## **ADDENDUM #2**

### **45th to 52nd Avenue Drainage Improvements City of Isle of Palms, SC RFP 2017.03**

**June 30, 2017**

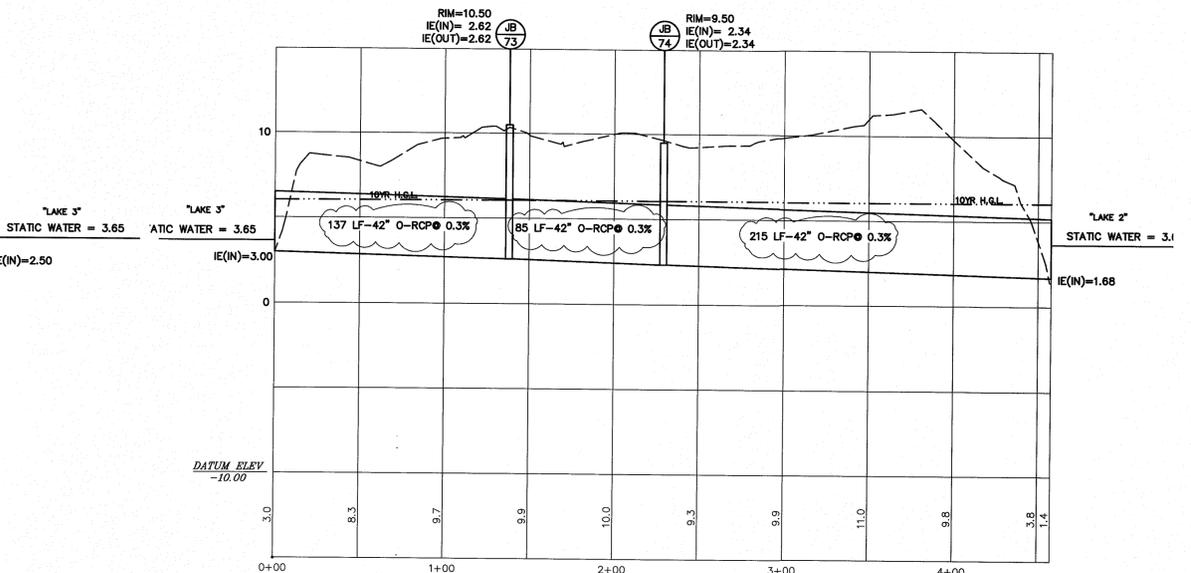
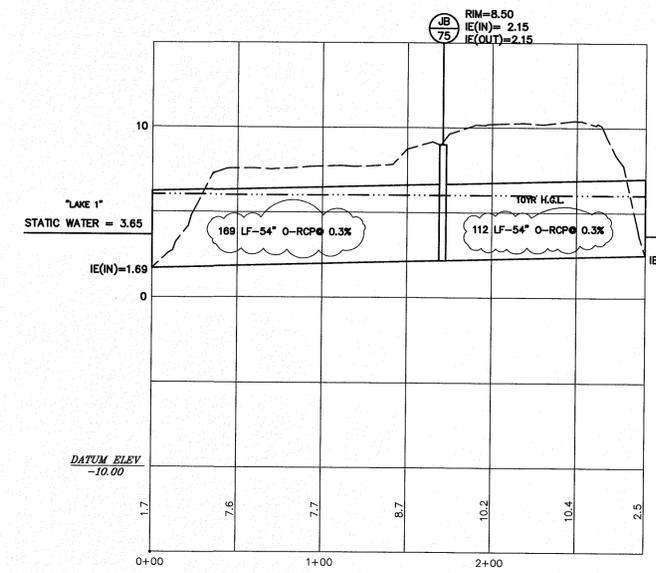
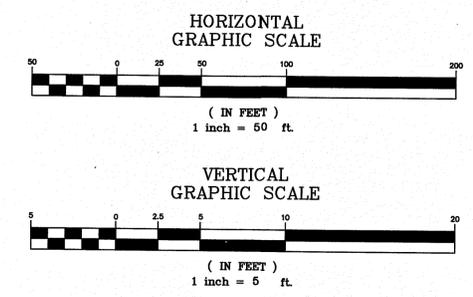
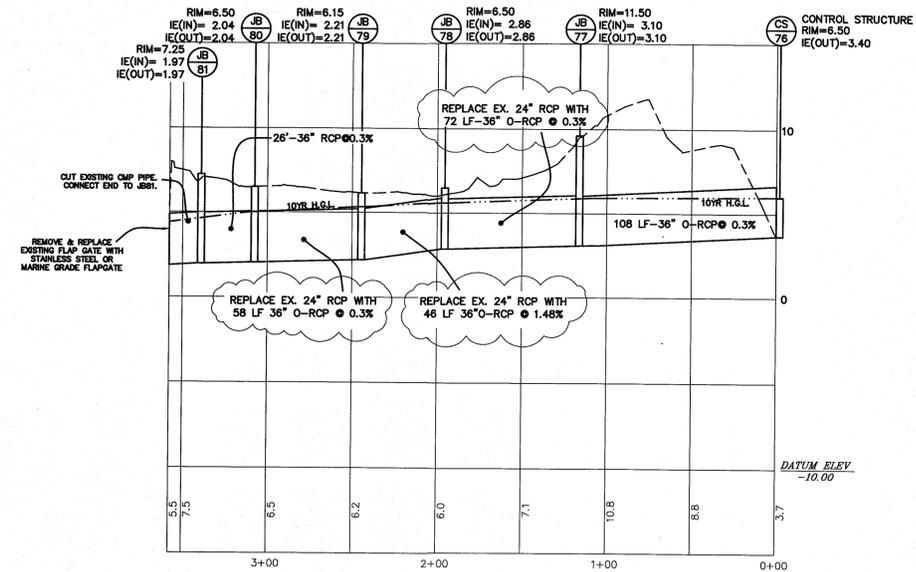
1. Sheet C200 - Revisions to Pipe Chart and Structure Chart to resolve pipe length and size and structure type discrepancies with Drainage and Erosion Control Plan sheets. Reference to JB23, JB29, JB30, JB31 removed from Pipe Chart as they are not included in plans.
2. Sheets C300, C301, C302 - Revisions to profiles to resolve pipe length and size and structure id number discrepancies with Drainage and Erosion Control Plan sheets
3. Sheet CD-2 - Added Temporary Cart Path Detail

CSE JOB NUMBER  
**920-PH2**  
 SHEET NUMBER  
**C300**

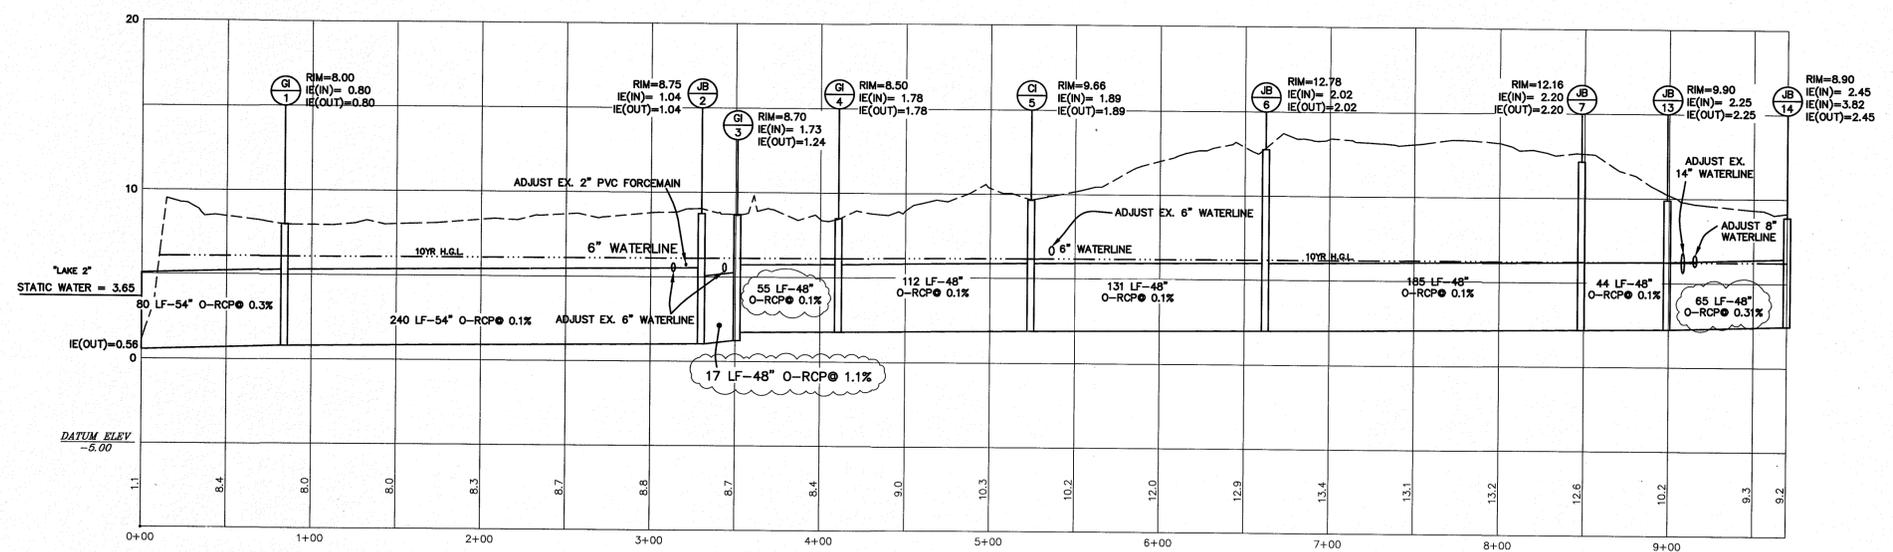
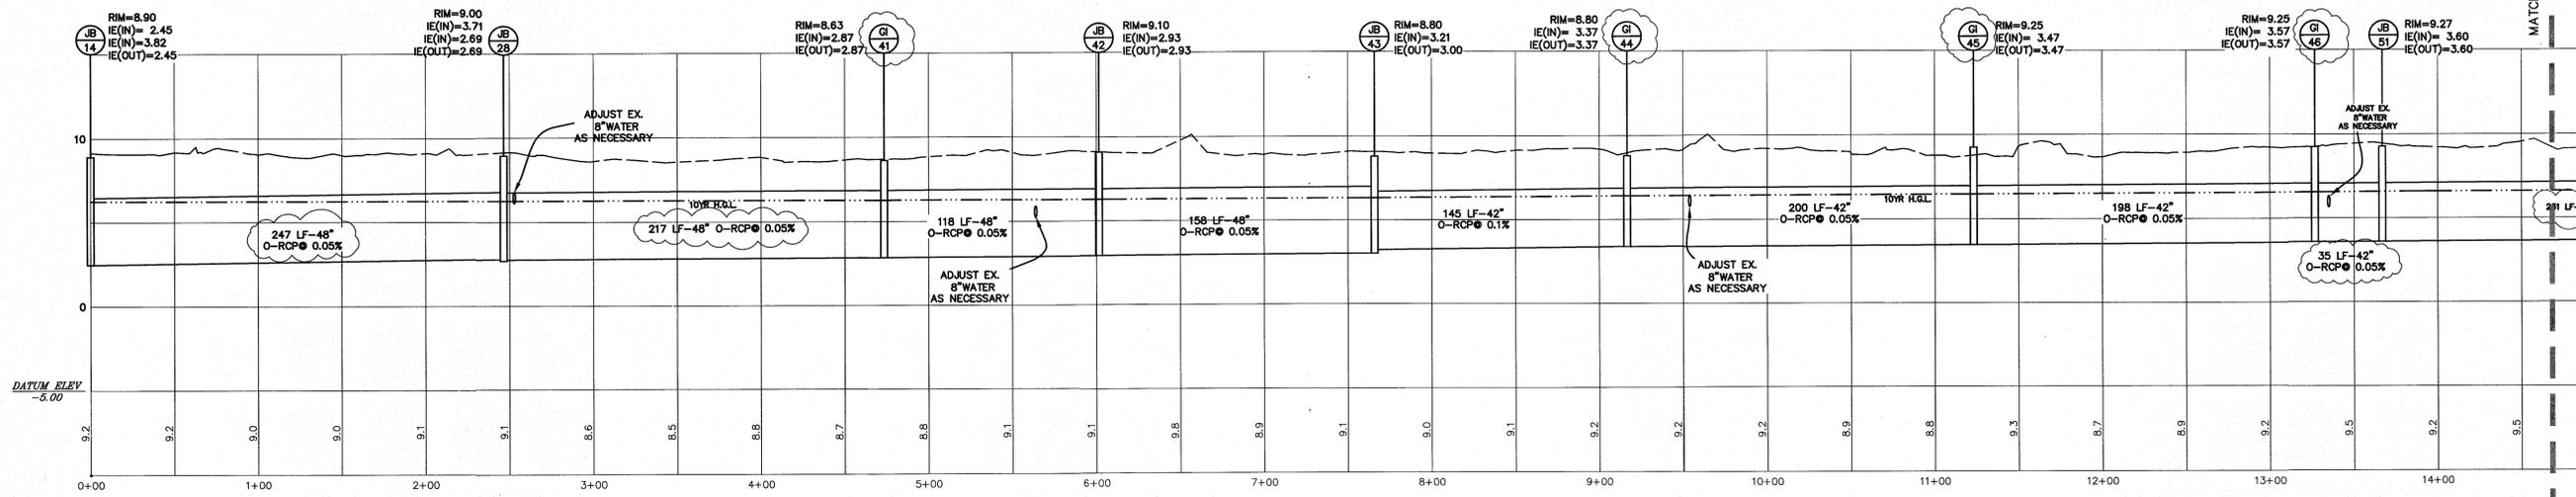
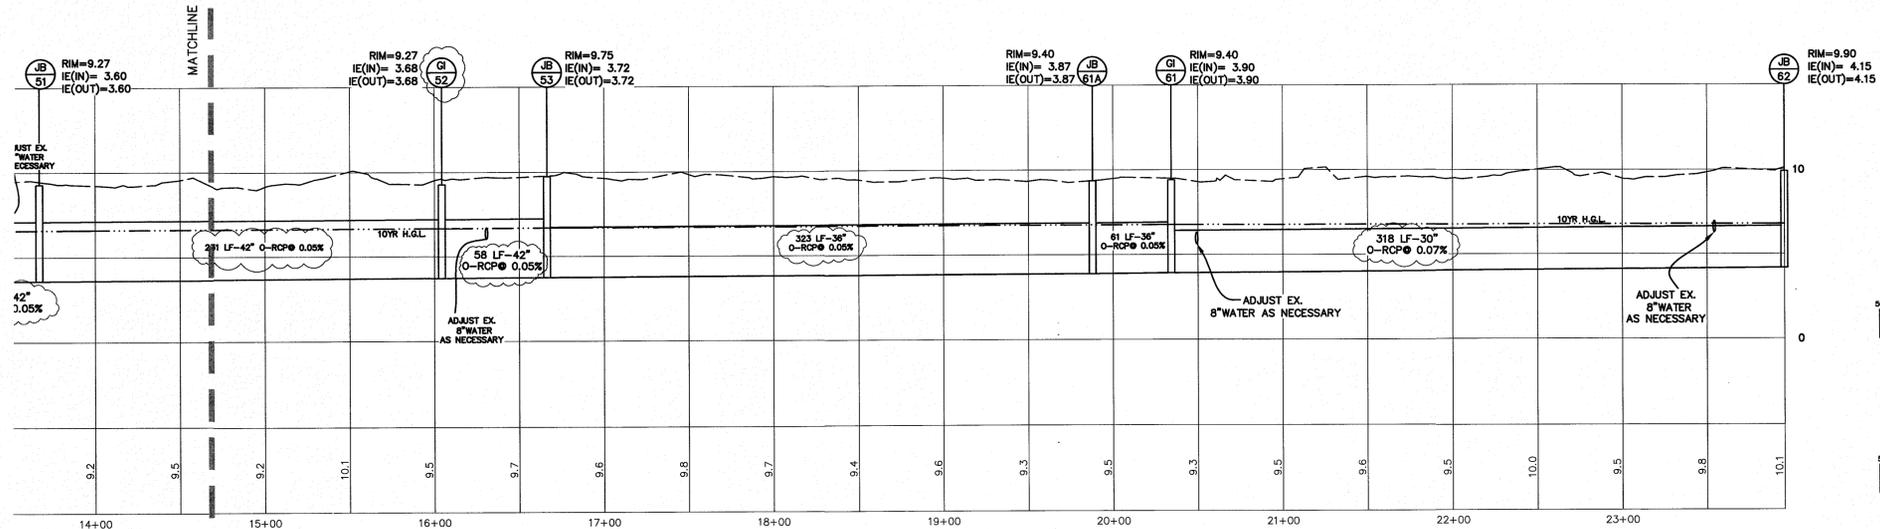
Question 12: " I noticed that the plan pages show different pipe sizes/shapes (round & elliptical) and quantities compared to what the profiles show in many cases. Which quantities and sizes should we be using; the plan page or the profile page? Also, are all the JBØ, GIØ, CsØ going to be removed and/or replaced? Some of the GIØ are labelled as JBØ as well, or vice versa."

**Answer 12: Grading and Erosion Control Plan sheets (C201-C207 of Construction Drawings) show correct quantities and sizes. Revised pipe and structure charts and plans & profiles are included as part of this addendum. All existing junction boxes, grate inlets and curb inlets indicated on plans as "remove/replace " are intended to be removed and replaced with new structures to accommodate increased pipe sizes that will be connected to an existing system.**

REVISIONS:  
 1) REV 8/23/13 PER LOWE WILD DUNES SCDOT, OPENSC COMMENTS/INFO  
 2) REV 7/16/14 PER SCDOT COMMENTS  
 3) REV 5/31/17 CONSTRUCTION BID SET  
 4) REV 6/30/17 RESOLVED DISCREPANCIES BETWEEN PLAN & PROFILES

TEMPORARY CART PATH  
NTS

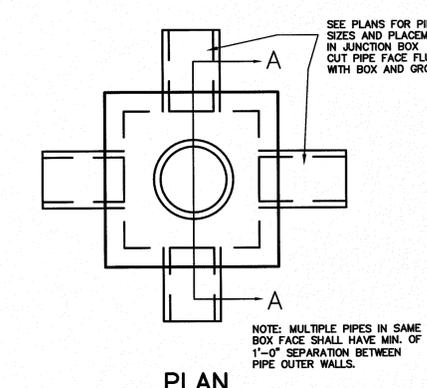
Question 15: Please provide detail for temporary cart path.

**Answer 15: Temporary Cart Path Detail added to revised Detail Sheet CD-2**

REVISIONS:  
1) REVISED 7/16/14 PER SCDOT COMMENTS  
2) REVISED 5/21/17 ADDED CHECK VALVE NOTE  
3) REVISED 6/20/17 ADDED TEMPORARY CART PATH DETAIL
